Technical Bulletin

RA04-002b

CLICKING NOISE FROM REAR AXLES DURING TAKE-OFF/ACCELERATION

APPLIED VEHICLES: 2004-2010 Armada (TA60)

Figure 1

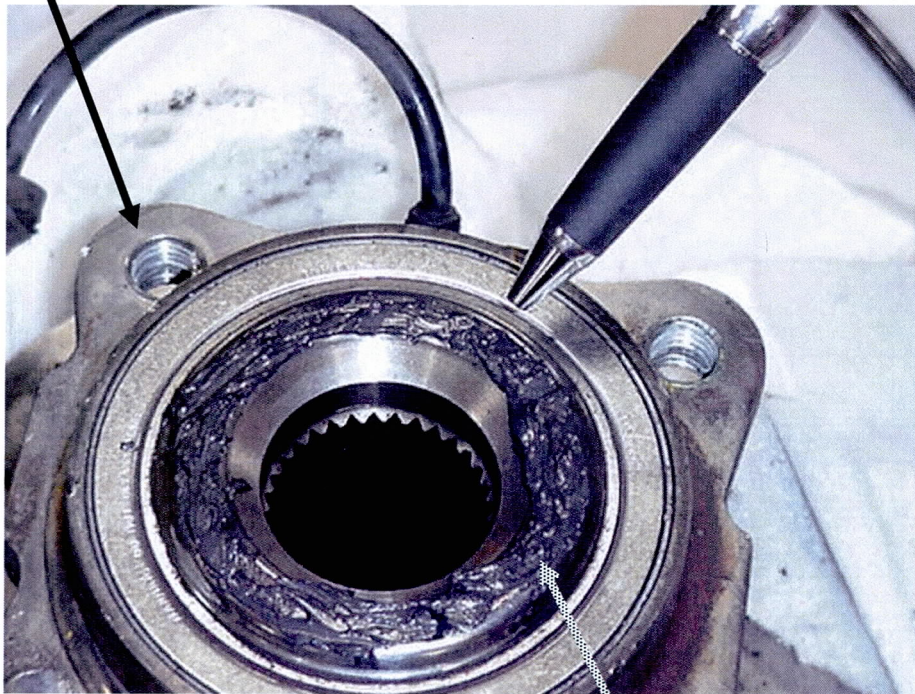
1. Remove both Rear Axle Hubs. Refer to the **RAX** section of the applicable Service Manual for the removal procedure.
2. Clean all dirt and foreign material from both axle shaft-to-bearing mating surfaces.
3. Apply a minimum of 1.0g of Molykote M77 Grease (P/N 44003-7S000CM) in an even coating to the bearing surface where it contacts the rear axle (see Figure 1).
4. Re-install the Rear Axle Hubs per the Service Manual instructions.
 - Use new Bolts when re-installing Rear Axle Hubs. See Parts Information.
5. Tighten the Axle Nuts to the **new** specification of:
 - 206 – 216 N•m (21 – 22 kg-m, **152 - 160 ft-lb**)
6. Test drive the vehicle to confirm the incident is resolved.
